PLANNING & ZONING COMMISSION MARCH 2024

TO: Michelle Eddy, CMC/CPM - Town Manager/Clerk

RE: Planning/Zoning/Architectural Guidelines review – 0537 Blue River Rd

STAFF REPORT

ACCESSORY BUILDING 24' X 30' = 720 SQ FT

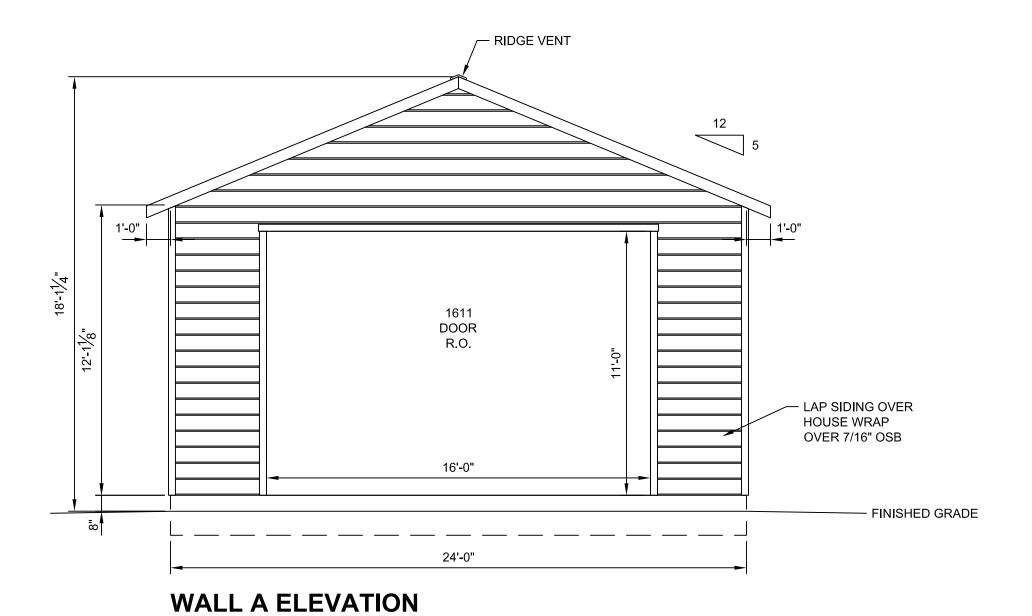
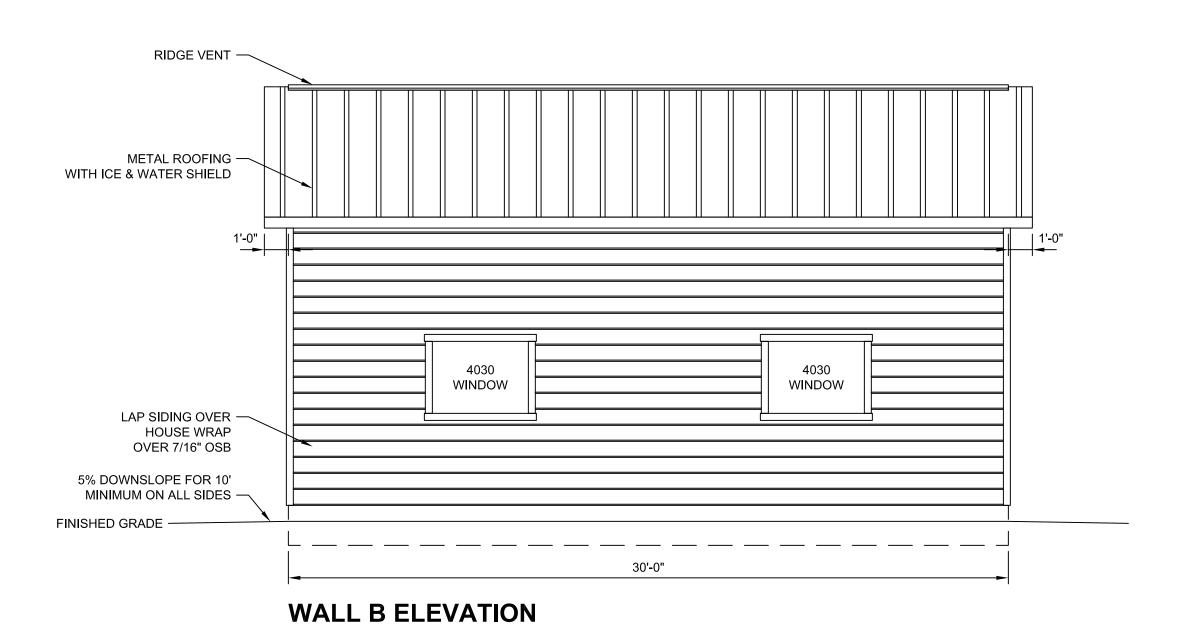
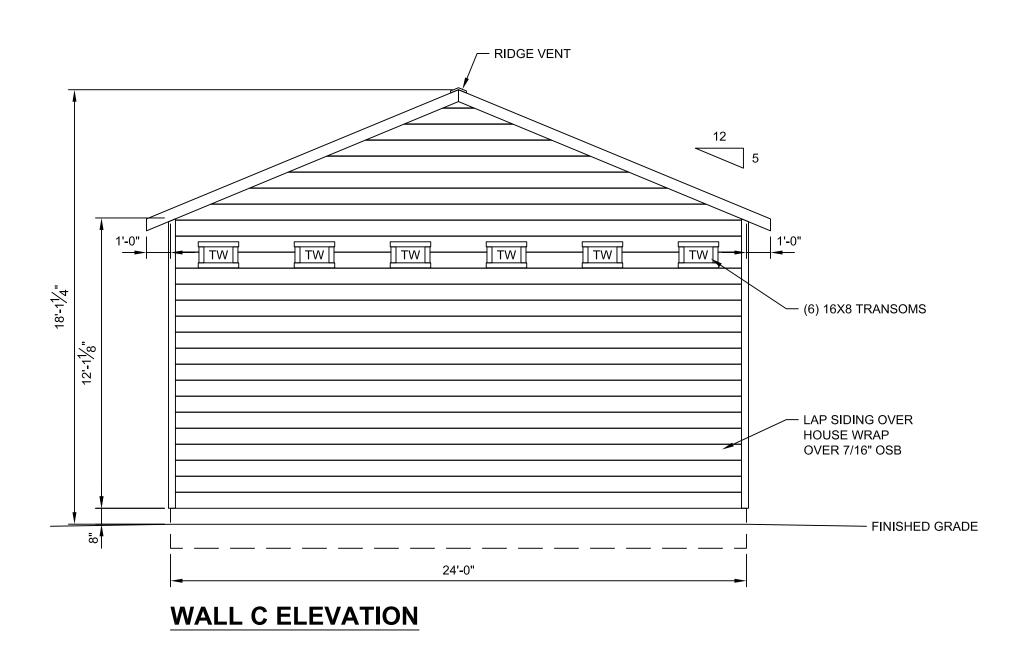
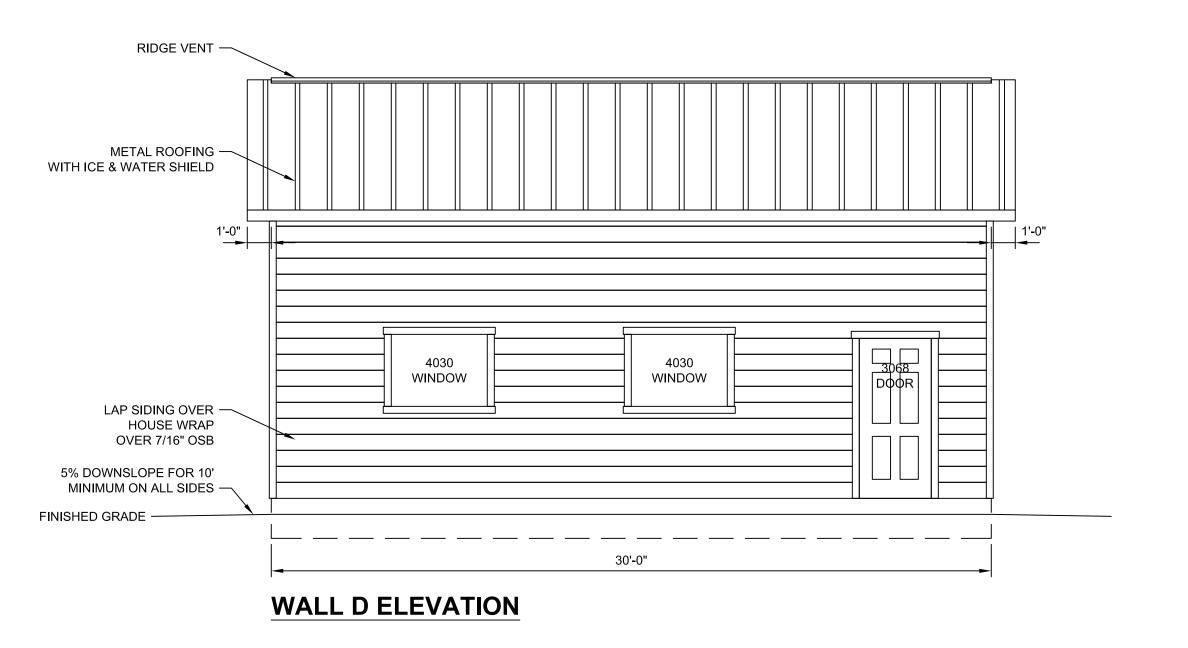
STANDARD NOTES/REMARKS		SUBSTANTIAL COMPLIANCE
DEVELOPMENT STANDARD		
Article 3: Easements	Easements are indicated and show compliance	Y
Article 4: Buildable Area/setbacks	Setbacks are indicated and show general compliance	Υ
	Article 5 Building Design Standards	
Article 5-20 Building Height	Building height is 18' and shows general compliance with accessory structures.	Y
Article 5-60 Foundation	Foundation is proposed as a monolithic slab. Visual elements show general compliance.	Y
Article 5-70 Roofs	Roofing material is indicated as metal roofing	Y
Article 5-80 Garages	Project is a proposed garage	Y
Article 5-90 Window and Door	Proposed structure includes a main garage door, man door, two side windows and transoms. Structure shows general compliance.	Υ
Article 5-100 Balconies and railings	N/A	Υ
Article 5-110	N/A	Υ

Chimney and Roof Penetrations				
Article 6 Building Materials and Colors				
Article 6-20 Materials	Wall material is proposed as horizontal cement lap siding, and roof is proposed as metal. Unclear if roof is proposed as standing seam or not.	PC		
Article 6-30 Colors	Color is indicated as Ghost Writer, and Knights Armor. Color samples are not provided. Indicated to be greys on tuff shed sheet 1. Unclear of garage door color.	PC		
	Article 7 Accessory Improvements			
Article 7-(20-40, 110) Berms, Garages, sheds and Gazebos	N/A	Y		
Article 7-50 Driveways	N/A	Υ		
Article 7-60 Parking Areas	N/A	Y		
Article 7-100 Decks	N/A	Υ		
Article 7-120 Hot Tubs	N/A	Y		
Article 7-140 Fences	N/A	Y		
Article 7-150 Retaining walls	N/A	Y		
Article 8 Signs				
Article 8 Signs	N/A	Υ

Article 9 Lighting			
Article 9 Lighting	No lighting is indicated	Y	
	Article 13 Environmental Regulations		
Article 13-20 Wetlands	N/A	Y

Deck construction:

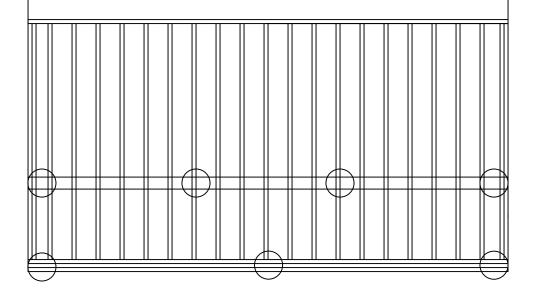
Snow Load/Live Load= 100 PSF

Snow Load/Live Load= 140 PSF
